Technical Bulletin

Bulletin No: TCH-013-008 **Effective Date: 9/24/04** **Cancels: N/A** **Page: 1 of 1**

Subject: **Bendix® is Replacing WS-20™ with WS-24™ Antilock Wheel Speed Sensors**

FIGURE 2 - ***PREVIOUS AND NEW CLAMPING SLEEVES***

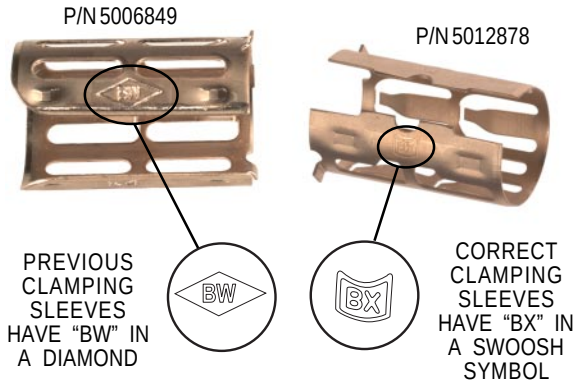
Please note that WS-24™ wheel speed sensors must use clamping sleeve p/n 5012878 instead of p/n 5006849. Always use correct clamping sleeves to avoid problems associated with reduced retention force, such as sensor movement and resulting ABS trouble codes.
